Mandatory Service Bulletin
No. MSB-E4-022/1

No. MSB-E4-022/1
SUPERSEDES MSB-E4-022

Waste Gate Control Rod.

Engine type: E4
Engine model(s): E4, E4P
Serial number(s): all

Figure 4: Waste Gate Circlip

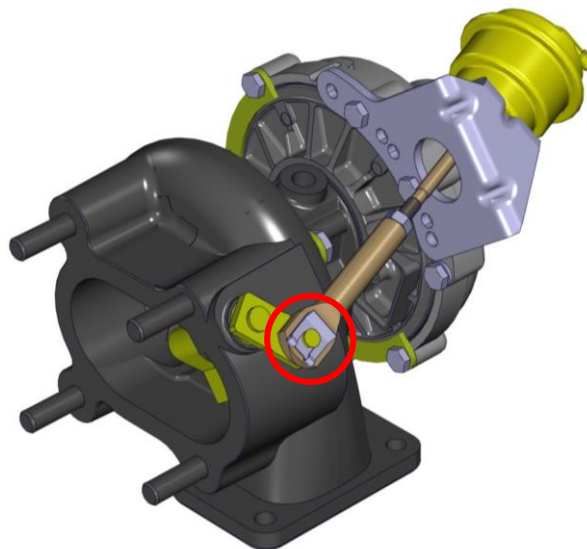
3. For waste gate controllers with markings as identified under 2. replace the waste gate controller with a waste gate controller not marked as listed under 2. according to Maintenance Manual section 81-00-33.
4. If MSB-E4-024/1 or RSB-E4-024 is not installed, replace the circlip DIN6799-5 with the spring loaded circlip E4A-41-100-801. For removal and installation refer to Maintenance Manual E4.08.04. Refer also to figure 4
